Access Compliance Report Public Rights-of-Way (Curb Ramps)

Main Street: IRVINE_BLVD Cross Street: CHIRPING_SPARROW_WAY Location: SW

ADA ID: RPRK211014150928 Ramp Type: Type 4 - Parallel Initial Pass/Fail: Pass Overall Compliance: No Severity Score: 6

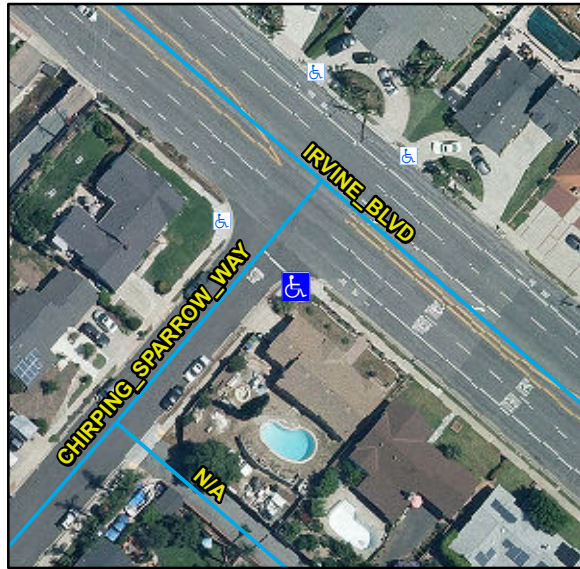
Crossing 1 Slope (%)	9.1		Crossing 2 Slope (%)	4.8
	Crossing 1 Cross Slope (%)	1.2		Crossing 2 Cross Slope (%)	2.1
Yes	Gutter Ponding	No	Yes	Curb Slope	4.6
Yes	Gutter Lip Height (in)	0		Road Run Slope (%)	7.8
No	Gutter Run Slope (%)	9.2		Road Cross Slope (%)	2.6
Yes	Gutter Cross Slope (%)	1.2	Yes	Perpendicular Joint Present	Yes
Yes	Overall Surface Condition	Acceptable			
	Cross Gutter Present?	No		Spandrel Present?	No
	Replace Cross Gutter?	N/A		Replace Spandrel?	N/A

Remove & Replace Gutter.

R304.5.4, STD 1115
